TruVision TVN 12 Release Notes

P/N 1157-EN • REV C • ISS 28NOV24

Firmware version 2.1.1 Build 241030

- **Configuration of log retention time**

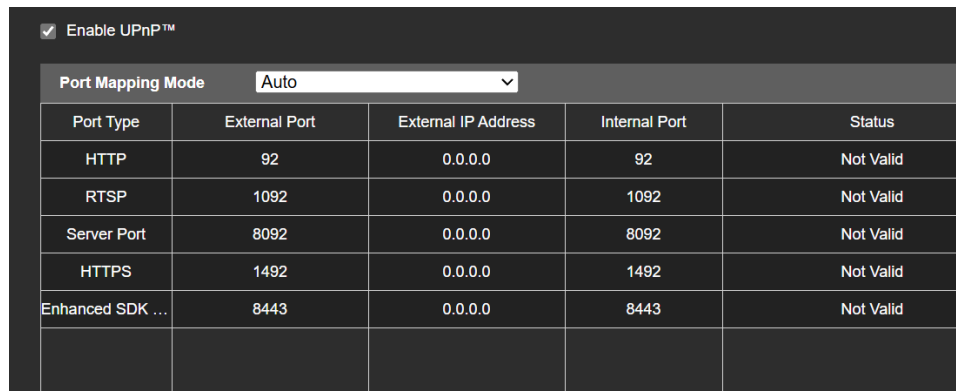
It is now possible to specify the log retention time in the recorder. The retention time can be set between 1 and 180 days, regardless of the retention time for recordings.

This setting is only available via the webpage and can be found in the menu **Configuration > Record > Advanced Settings > Other**
